## **Pacific Gas and Electric Company's (PG&E's) 2016 Energy Storage Request for Offers ("RFO") Frequently Asked Questions**

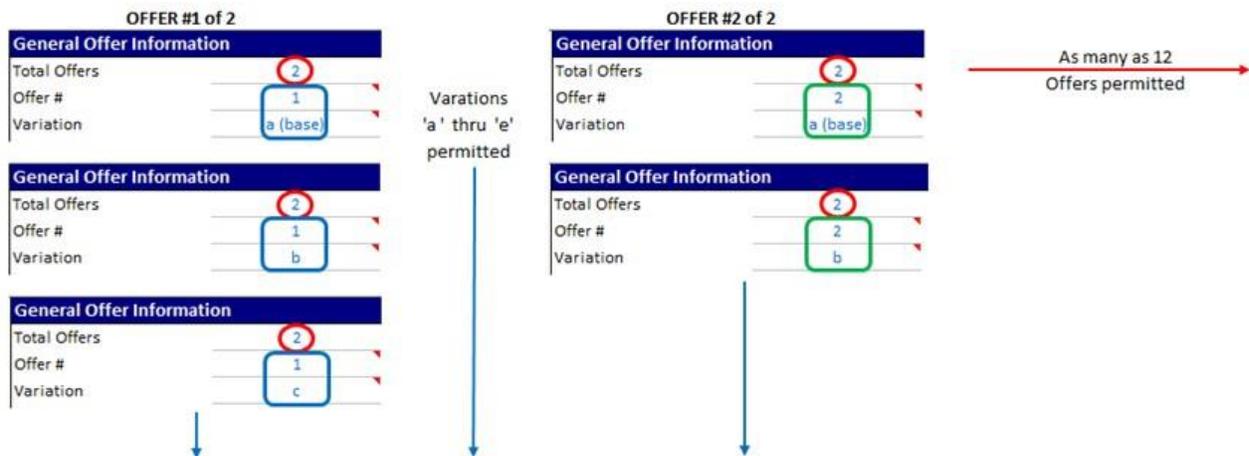
- Could PG&E clarify the difference between offers and variations, and how to number/letter them?

**Example:** Offer Form screenshots for two Offers are illustrated below. The first Offer (PSA) has 3 variations, a → c. The second Offer (CSA) has two variations, a → b. In the illustration below there would be five (5) Offer Form workbooks submitted, for the five (5) unique variations. Each Offer should submit a complete Offer package of applicable appendices. PSA packages should not include CSA information and vice versa.

Participants may submit up to twelve (12) Offers. Changes in a Project’s location, technology, or specific agreement type (e.g., CSA or PSA) would result in a new Offer. Participants may submit up to ten (10) variations. If a Project’s location, technology, or specific agreement type remain constant, then changes in other characteristics such as delivery term, price, commercial operation date, capacity, or duration would constitute a unique variation.
